**AMENDMENT NO. 8**  
**ADDITION OF 24PTH DSC**

**TO**  
**NUHOMS<sup>®</sup> COC 1004**  
**DSC TO STANDARDIZED NUHOMS<sup>®</sup>**  
**SYSTEM**

### **Description, Justification, and Evaluation of COC Amendment Changes**

### **Suggested Changes to Technical Specifications of CoC 1004 Amendment No. 7**

**Figure 1-10**  
***Soluble Boron Concentration vs. Fuel Initial U-235 Enrichment***  
***for the 24PHB System***

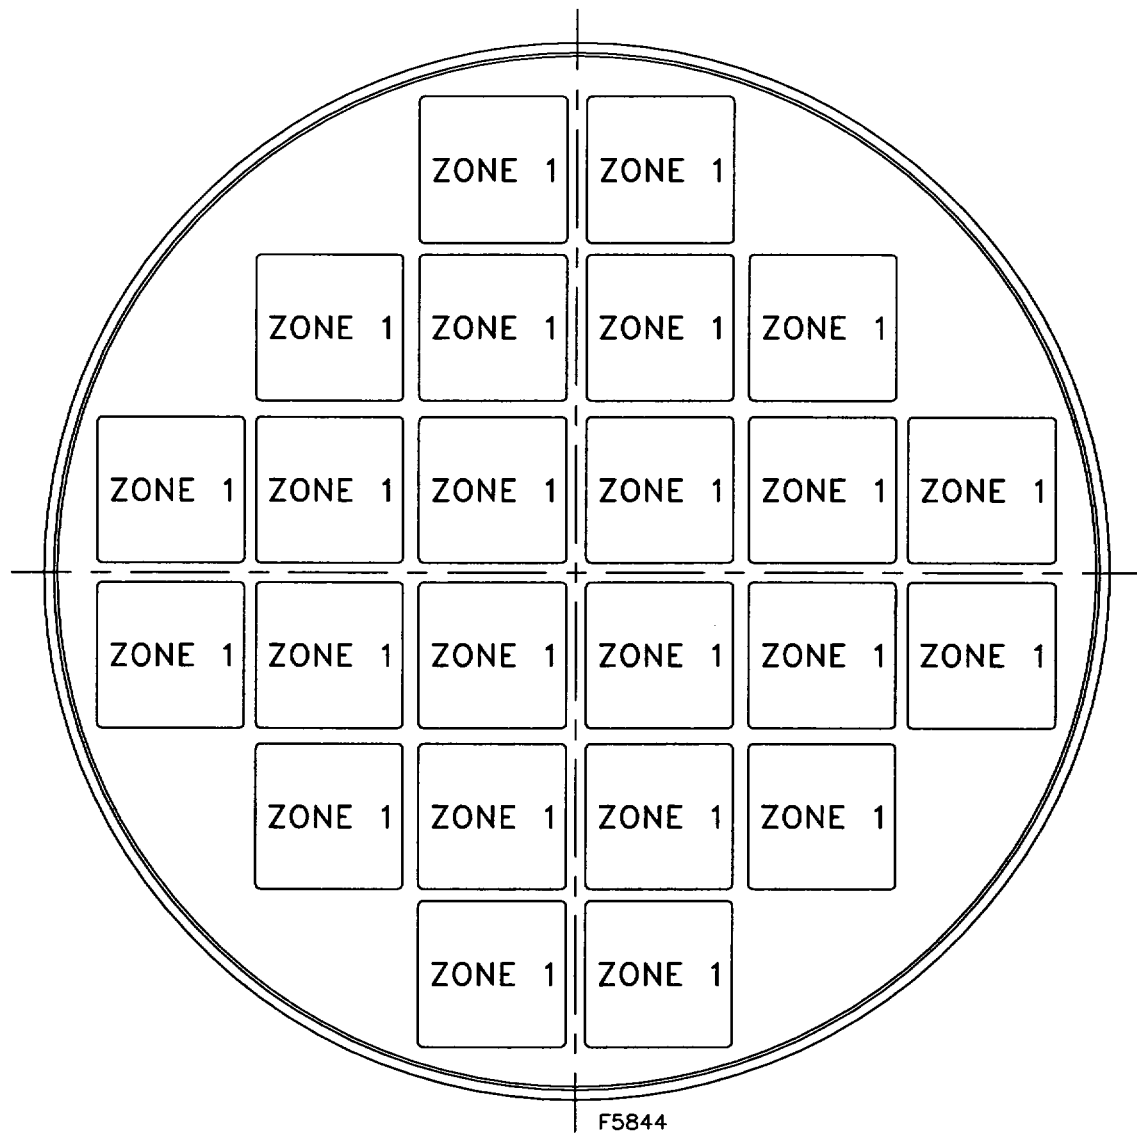
- Add Fuel Qualification Tables 1-3e, 1-3f, 1-3g, and 1-3h for the NUHOMS®-24PTH DSC (PWR Fuel with CCs).
- Relocate the existing Figure 1-10 from its existing location (page A-65) to page A-63 as shown. This is an editorial change and represents a more logical location for this Figure in the Technical Specifications.

**Figure 1-11**  
**Heat Load Zoning Configuration No. 1 for 24PTH-S and 24PTH-L DSCs (with or without Control Components)**

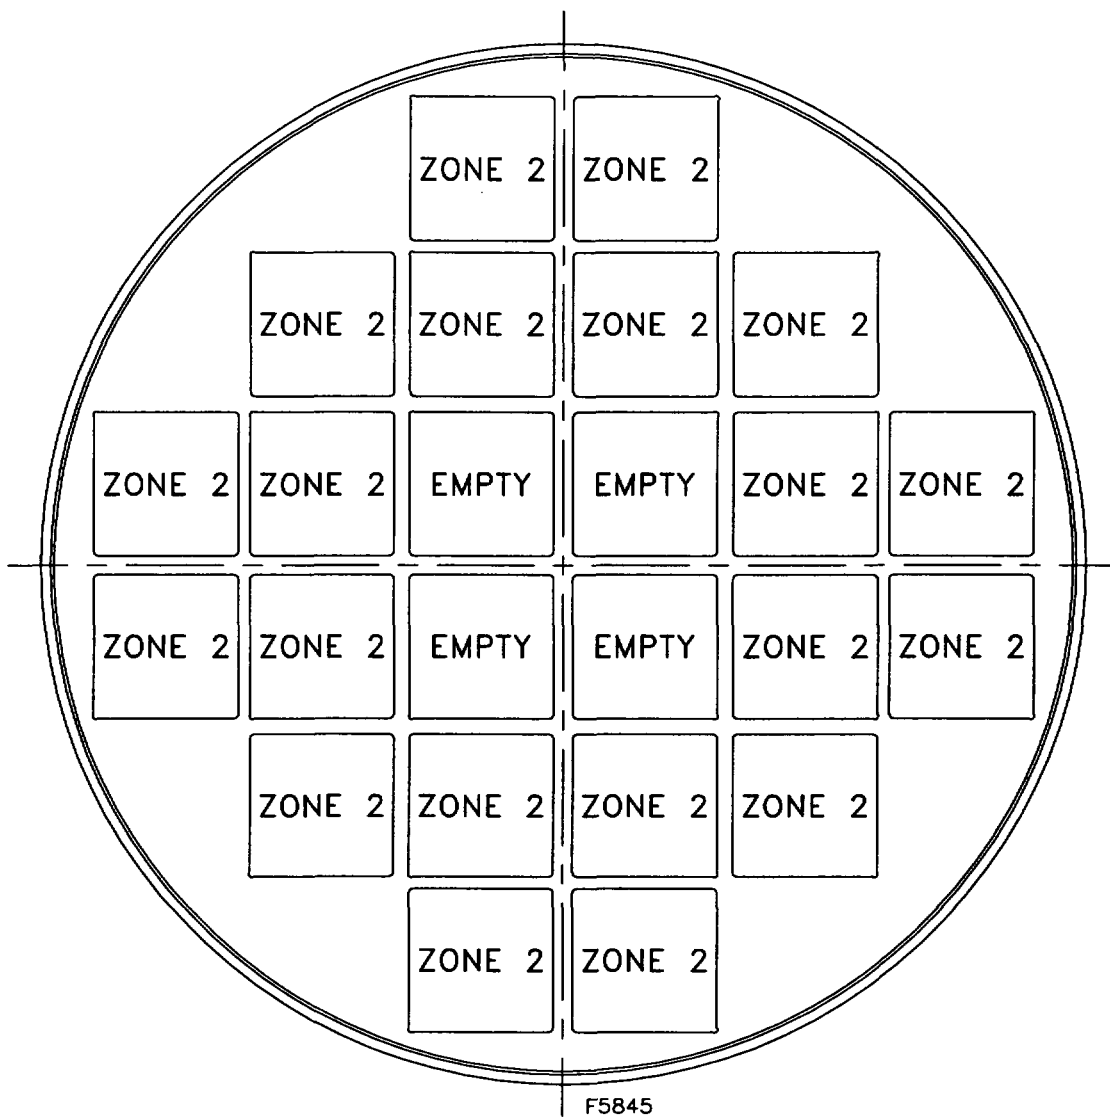
- Add Figures 1-11, 1-12, 1-13 and 1-14 to specify the four heat load zoning configurations analyzed for the 24PTH-S or 24PTH-L DSC. Add Figure 1-15 to specify the heat load zoning configuration analyzed for the 24PTH-S-LC DSC.
